Service Bulletin

Bulletin No.: 17-NA-201

Subject: Excessive Windshield Condensation, HVAC Defrost Door Flutter Type Noise Heard

Brand:	Model:	Model Year:		VIN:		Engine:	Transmission:
		from	to	from	to		
Chevrolet	Camaro	2016	2017

Flutter Noise:

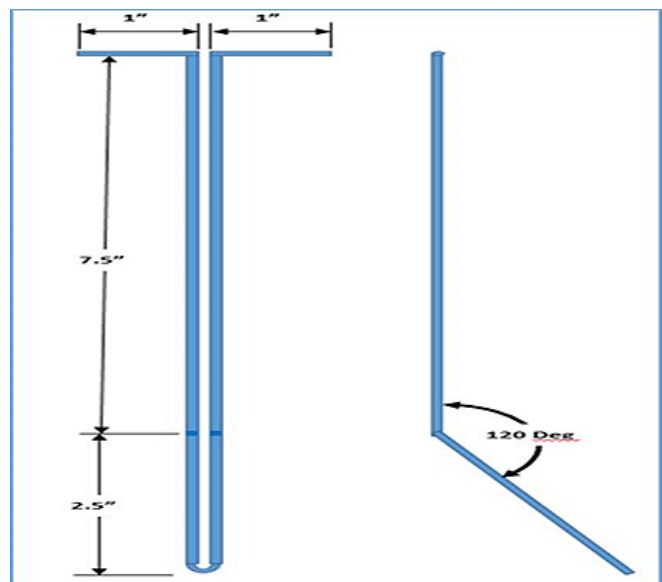
- An updated software calibration has been released to address the flutter type noise condition.
- Remove both foam pads located on the defrost door to address the excessive windshield condensation then update the software to address the flutter issue that results when the foam is removed.

Reprogram the HVAC system control module with the latest calibrations available on TIS2WEB. Refer to *HVAC System Control Module Reprogramming with SPS* in SI.
